NUMBER: B400R1038-0

Ride: GIANT GONDOLA WHEEL

Subject: Hydraulic Leveling Cylinder

Plumbing Rework

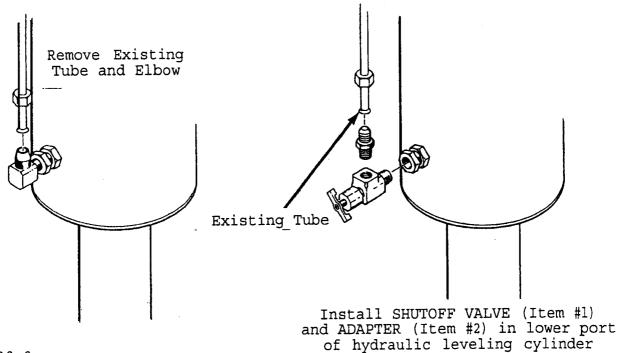
1. Extend the hydraulic leveling cylinders until they almost touch the base plate. All pressure must be releived from the hydraulic system, and no weight should be on the cylinders. Remove the tube and elbow from the lower port (rod end) of the cylinder.

- 2. Install the shut-off valve (Item #1) and adapter (Item #2) into the cylinder port. Reinstall the tube.
- 3. Repeat the procedure on the other eleven (11) leveling cylinders.
- 4. Check and fill the hydraulic reservoir to replace lost oil.
- 5. When transporting the ride, all shut-offs must be in the <u>CLOSED</u> position (tightened clockwise). Always open the valves after the ride is in position and ready for set-up.
